City of Somerville

PLANNING BOARD

TO: Planning Board
FROM: OSPCD Staff
SUBJECT: 720-722 Broadway, ZP24-000047 (Special Permit) & ZP24-000048 (Site Plan Approval)
POSTED: December 12, 2024

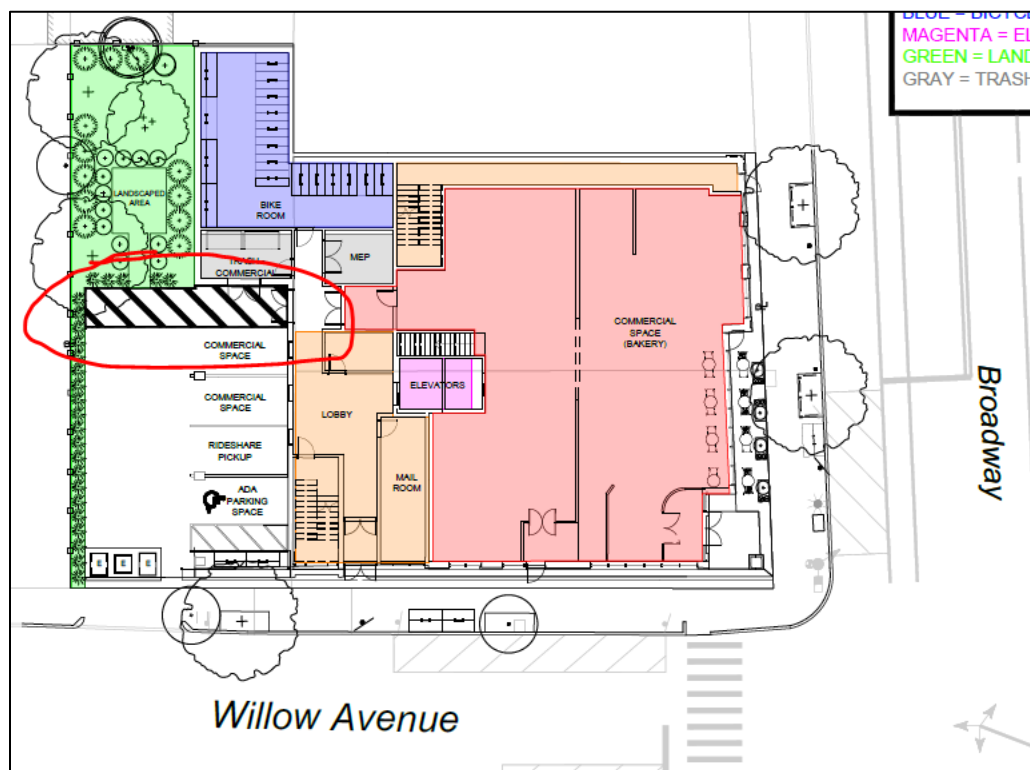
Mobility Staff have also commented that the previously approved TAP showed a hatched area in the parking lot between the door and the landscaped area, which the Mobility Division have requested be re-added to emphasize that the space should be kept clear of vehicles to maintain pedestrian access to the landscaped area. (The image below is a portion of the Illustrative Site Plan provided as part of the previously submitted TAP.)
